Information Only Notification

This is to inform you that a change is being made to the following products.

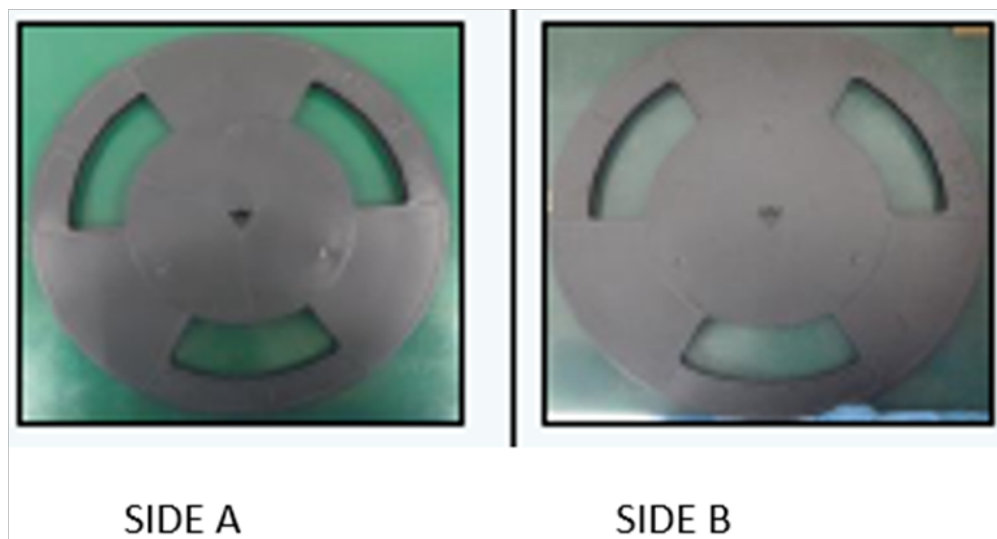
Description of Change (From) :

Current Lock reel supplied by GPI Malaysia has no poka yoke hole and is prone to mis-insertion and mis-reeling during Tape and Reel process.

Description of Change (To) :

New Lock reel from UPAK Philippines has 3 poka yoke holes that will prevent mis-insertion and mis-reeling during Tape and Reel process.

Reason for Change:

To prevent mis-reeling of devices during tape and reel operation and shorten the delivery lead time by 4-5 weeks, by ordering the parts from UPAK Philippines.
